Access Compliance Report

Public Rights-of-Way

(Pedestrian Signals)

Intersection ID: N/A	Main Street:	Cross Street: N/A	Location: N/A
ADA ID: 1CAB559EA9E4	Signal Type: One Push Button-APS	Overall Compliance: No	Severity Score: BTN 1: N/A BTN 2: N/A No BTN: N/A
Codes/Mitigation Info/Possible Solution		Field Measurements/Component Compliance

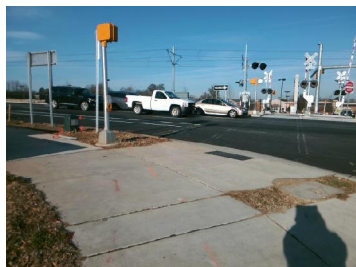
PROW/ADA: TMUTCD 4e.08, R404.2, R404.3, R404.7.3, R404.7.2,

Compliance	Description	Data	Compliance	Description	Data
	Button Count	Button1	Yes	Distant to Additional Button (in)	338.0
	Additional Button Present?	Yes		Additional Button ID	5B465F4EF480
N/A	Signal Buttons Required?	N/A	N/A	Additional Ped Posts Required	N/A
	How Many Ped Street Xings?	N/A		Located In An Island/Median?	N/A
N/A	B 1 Sign Present?	Yes	N/A	B 2 Sign Present?	N/A
Yes	B 1 Sign Purpose?	Yes	N/A	B 2 Sign Purpose?	N/A
Yes	B 1 Sign Lettering & Contrast?	Yes	N/A	B 2 Sign Lettering & Contrast?	N/A
Yes	B 1 Parallel To XWalk?	Yes	N/A	B 2 Parallel To XWalk?	N/A
Yes	B 1 PAR to Button?	Yes	N/A	B 2 PAR to Button?	N/A
Yes	B 1 PAR to XWalk?	Yes	N/A	B 2 PAR to XWalk?	N/A
Yes	B 1 Clear Floor Space?	Yes	N/A	B 2 Clear Floor Space?	N/A
N/A	B 1 FWD Approach?	No	N/A	B 2 FWD Approach?	N/A
N/A	B 1 FWD Approach Constrained?	N/A	N/A	B 2 FWD Approach Constrained?	N/A
N/A	B 1 FWD Approach Reach (in)	N/A	N/A	B 2 FWD Approach Reach (in)	N/A

N/A	B 1 FWD Approach Width (in)	N/A	N/A	B 2 FWD Approach Width (in)	N/A
N/A	B 1 FWD Approach Obstruction?	Yes	N/A	B 2 FWD Approach Obstruction?	N/A
N/A	B 1 FWD Approach Obstruction Dist (in)	4.0	N/A	B 2 FWD Approach ObstructionDist (in)	N/A
N/A	B 1 PARA Approach?	Yes	N/A	B 2 PARA Approach?	N/A
N/A	B 1 PARA Approach Constrained?	Yes	N/A	B 2 PARA Approach Constrained?	N/A
No	B 1 PARA Approach Reach (in)	11.0	N/A	B 2 PARA Approach Reach (in)	N/A
No	B 1 PARA Approach Width (in)	48.0	N/A	B 2 PARA Approach Width (in)	N/A
N/A	B 1 PARA Approach Obstruction?	Yes	N/A	B 2 PARA Approach Obstruction?	N/A
N/A	B 1 PARA Approach Obstruction Dist (in)	5.0	N/A	B 2 PARA Approach ObstructionDist (in)	N/A
No	B 1 Clear Floor Space Slope (%)	2.1	N/A	B 2 Clear Floor Space Slope (%)	N/A
No	B 1 Clear Floor Space XSlope (%)	6.1	N/A	B 2 Clear Floor Space XSlope (%)	N/A
N/A	B 1 PAR Slope (%)	N/A	N/A	B 2 PAR Slope (%)	N/A
Yes	B 1 Height (in)	38.0	N/A	B 2 Height (in)	N/A

N/A	B 1 Clear Xing Direction?	Yes	N/A	B 2 Clear Xing Direction?	N/A
	B 1 Crossing Direction	To NW		B 2 Crossing Direction	N/A
Yes	B 1 DistanceTo XWalk (in)	53.0	N/A	B 2 DistanceTo XWalk (in)	N/A
No	B 1 DistanceTo Curb (in)	77.0	N/A	B 2 DistanceTo Curb (in)	N/A
Yes	B 1 Diameter (in)	2.0	N/A	B 2 Diameter (in)	N/A

Possible Solutions: Replace Signal Push Button With APS Button on New Post. Remove & Relocate Sign.
